Technical Service Bulletin

Subject: REAR BRAKE NOISE	Bulletin No.: 04-001/24
	Last Issued : 09/10/2024

SECTION A-A

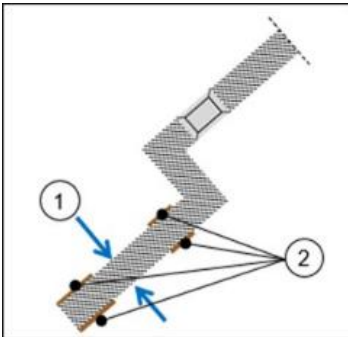
1. Verify the customer concern of grinding noise and/or vibration.
2. Check the disc surface to see if the cause of noise and vibration is the disc's rust (Some areas of the surface have fallen off due to rust and are too thin, which may look like black stains on the surface). If rust is the cause of the noise or vibration when applying the brakes, lath the discs or replace them with new ones and replace the brake pads.

- Check the disc thickness using a micrometer before lathing, if the thickness is below 8.7 mm for 2WD or 9.7 mm for AWD, replace the disc with new ones (DO NOT lath). Measure the thickness in the relatively less rusted area where the pads are hitting but not in the severely rusted area.
- Disc replacement is acceptable if an on-car lathe is not available.

Sample case: If lathe is not applicable.
Some areas of the surface have fallen off due to rust and are too thin.

NOTE: Measure the thickness at the least rusted area.

- (1) Measuring points
(2) Rust

3. After lathing the disc, re-measure the disc thickness. Replace the discs if the thickness is below the machining limit of 7.8 mm for 2WD and 8.8 mm for AWD as well as the brake pads. Refer to the instructions on MGSS online:
